ELMCREST DAM

NDI ID NO. PA-00347
DER ID NO. 35-142

PHASE I INSPECTION REPORT,
NATIONAL DAM INSPECTION PROGRAM

Prepared by
GANNETT FLEMING CORDDRY AND CARPENTER, INC.
Consulting Engineers

RESULTS OF
VISUAL INSPECTION

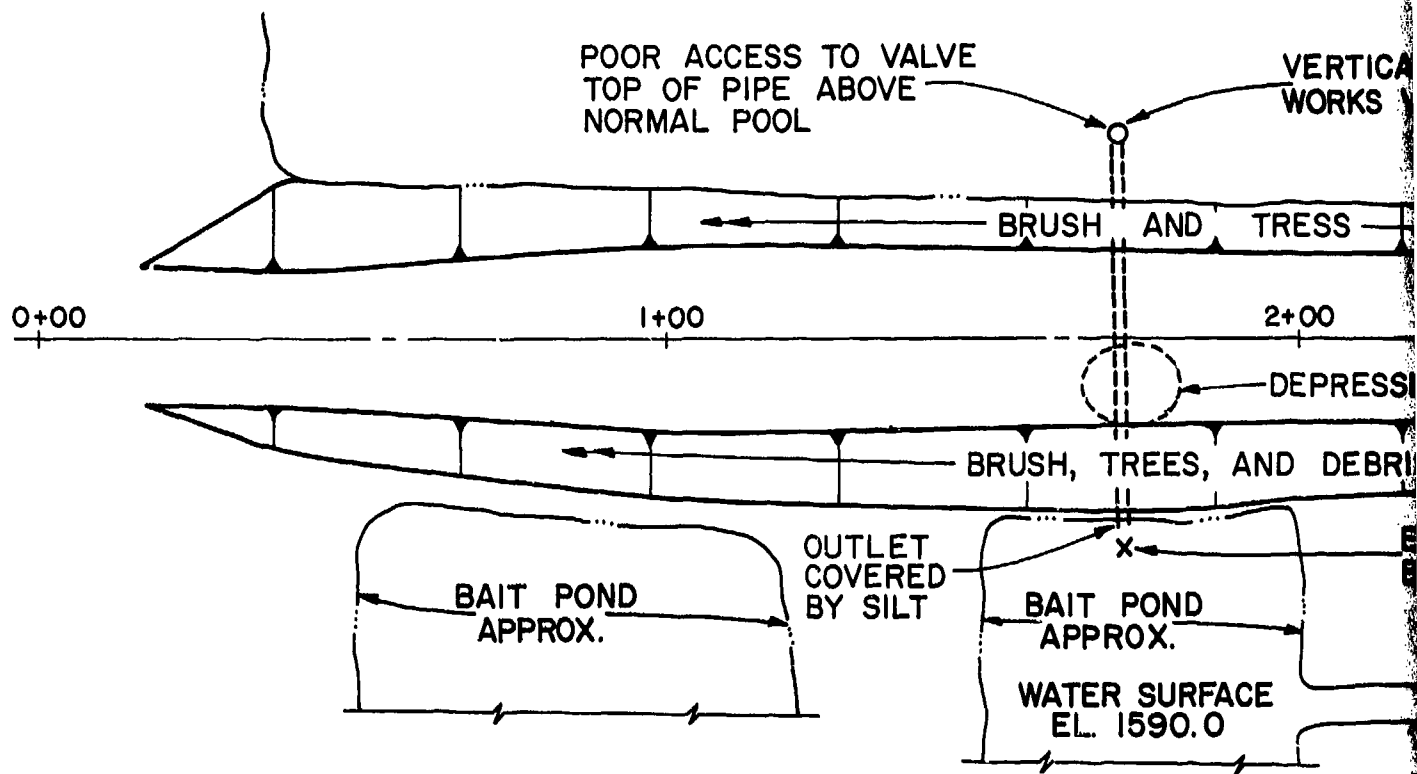
a. General. The overall appearance of the dam and appurtenant structures is fair. Deficiencies were observed as noted below. A sketch of the dam with the locations of the deficiencies is presented on Exhibit B-1 in Appendix B. Survey information acquired for this Report is on Plate E-2 in Appendix E. Datum used for the survey was the spillway crest, Elevation 1595.1, as estimated from USGS contour mapping. On the day of the inspection, the pool elevation was 0.5 foot above the spillway crest level.

E. Spillway

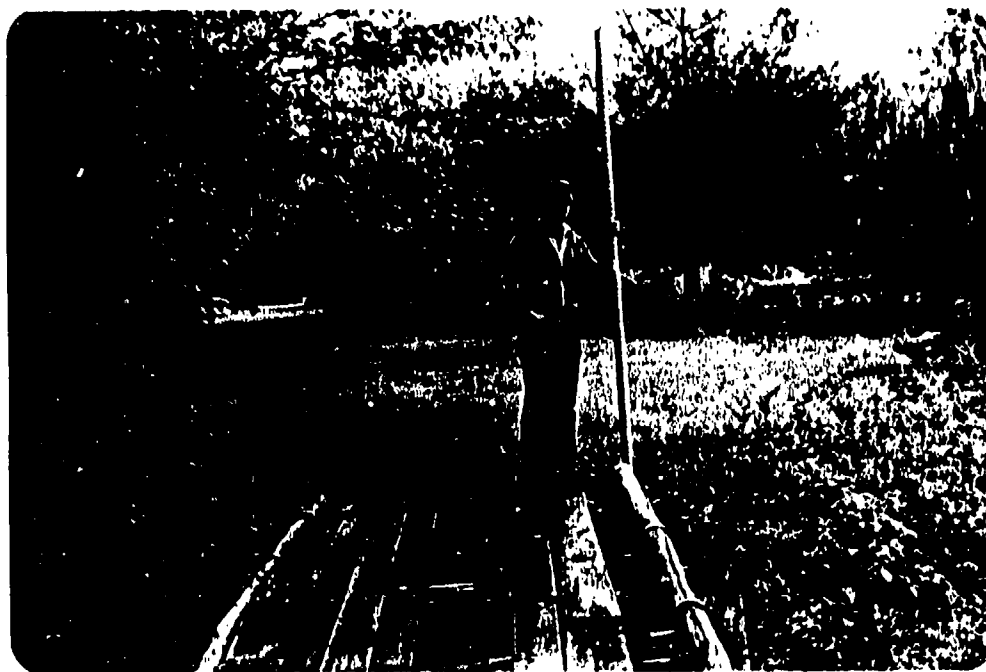
A minor amount of debris is accumulated at the spillway (Photograph E). The CMPs in the spillway are corroded through. The area of natural ground to the left of the spillway is heavily overgrown with thick brush and small trees. The right side of the spillway is the embankment. It is covered with vegetation. The spillway exit channel is not well-defined as it extends through the swamp to the bait pond.

(1) Design and construct a spillway capable of passing the SDF. The spillway should be designed so as to eliminate both the potential for collection of debris and the potential for erosion at the embankment.

F. Confluence of Spillway Exit Channel and Bait Pond

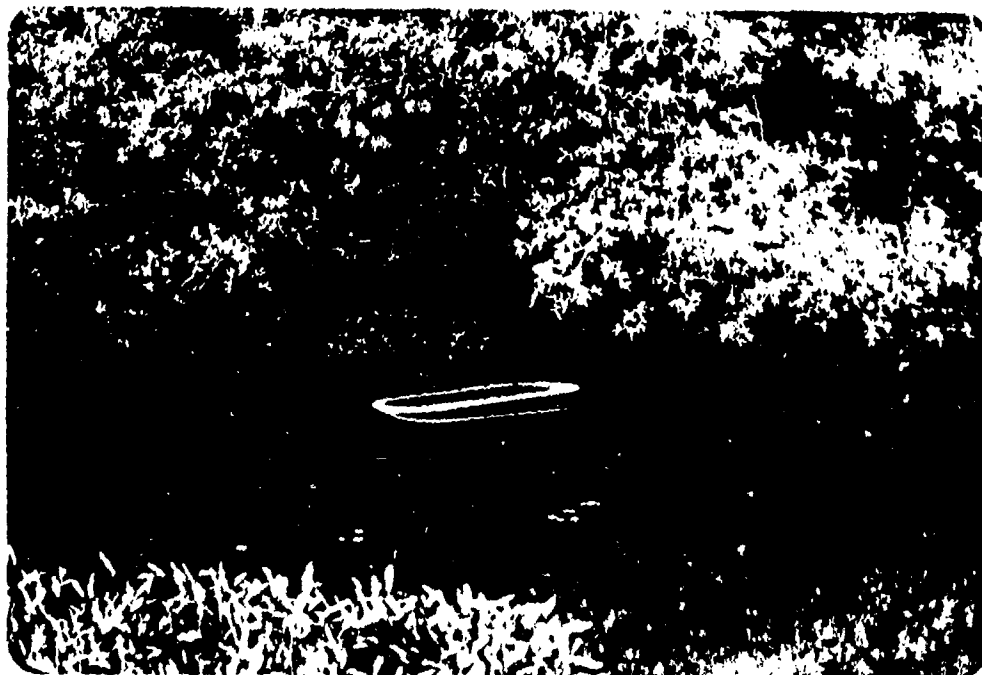
Two bait ponds extend downstream from the embankment, as shown on Plate E-2. Both the outlet works and the spillway channel discharge into the leftmost bait pond (Photograph F). The area between this bait pond and the spillway is a swamp. The swamp, which is heavily overgrown, extends for a significant distance downstream from the embankment. No seepage areas were observed, although they could have been obscured by the pond, swamp, and flow from the spillway.
